**CITY OF CENTRAL POINT  
PLANNING COMMISSION AGENDA  
August 4, 2020 - 6:00 p.m.**

Consideration of a Site-Plan and Architectural Review application to construct a mixed-use development on 2.19 acres in the Twin Creeks TOD. The project includes 6,132 square feet of commercial first floor space, 10 furnished first floor VRBO spaces and 56 residential units consisting of a mixture of apartments and townhouses. Ten townhouses are proposed along Golden Peak Drive to transition to the single family residences to the north. There is a plaza associated with commercial use and parking is provided internal to the development. The site is within the High Mix Residential (HMR) zone and is identified on the Jackson County Assessor’s Map as 37 2W 03CA, Tax Lot 1100. **Applicant:** Smith Crossing LLC; **Agent:** Scott Sinner Consulting, Inc. (Scott Sinner)

Attachment "A" – Project Location Map  
Attachment "B" – Central Point Station Plot Plan  
Attachment "C" – Central Point Station Landscape Plan  
Attachment "D-1" – Building 1 – Mixed Use, 4-Story Elevation  
Attachment "D-2" – Buildings 2/3 - 15-Plex Elevations

# ATTACHMENT "B"

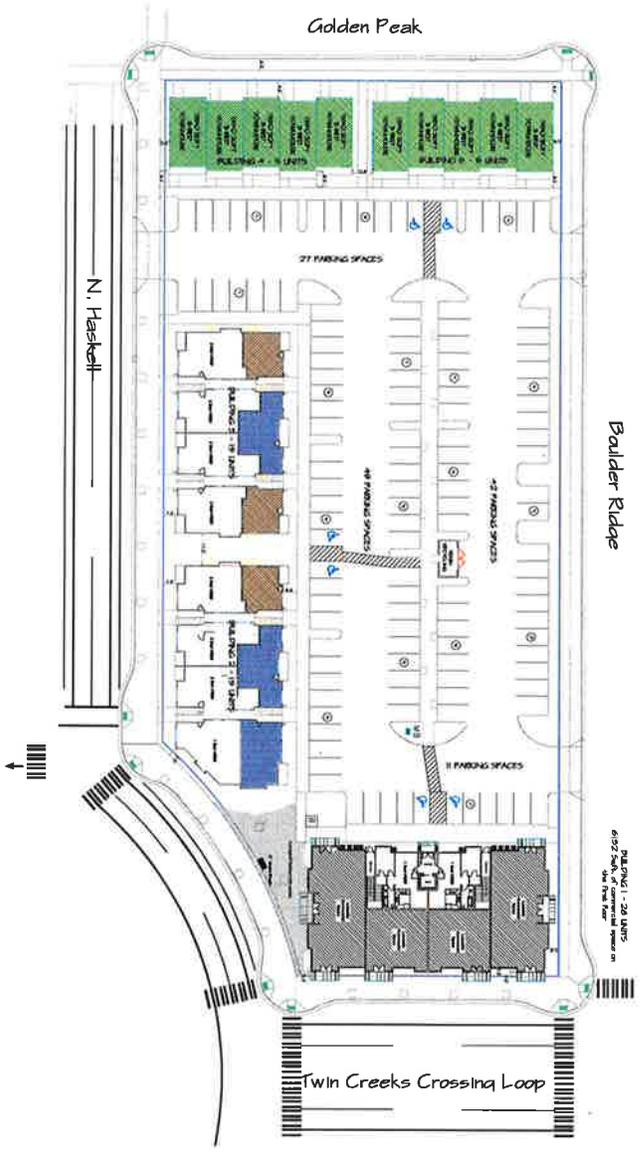
Comment: The Agent for the applicant states, the North Haskell frontage proposes a driveway access between buildings 3 and 4. The location of the access is as far from the Twin Creeks Loop as possible and provides a transition area between the 3-story buildings 2 and 3 and the 2-story buildings 4 and 5 (Attachment “F”). The original alignment is not critical to the access and staff recommends the Planning Commission grant the request to improve the overall design for both access and architectural consideration.

4. **On-site Lighting.** The proposed site plan does not address the on-site lighting standards necessary to illuminate building entrances, the parking lot and pedestrian walkways per CPMC 17.67.050(L). Although this is a minor issue, it will be necessary to provide a revised site plan with the details for proposed building and parking lot lighting to comply with the on-site lighting standards.

Comment: The applicant has stated in their findings that lighting is a design-build contract and was not included in the development proposal in case there were changes to the parking lot. A condition has been added to address on-site lighting.

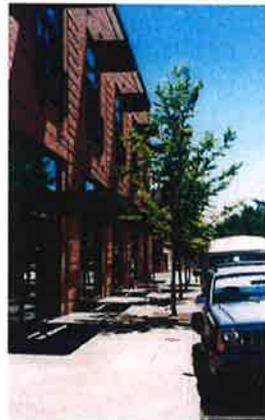
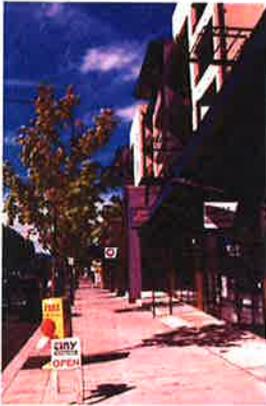
Comment: The TCMP encourages street frontages to be pedestrian friendly with active public space. *Buildings are detailed to provide a strong emphasis to a corner, with continuity of architectural detailing and materials on the front and side facades* (Attachment “G”).
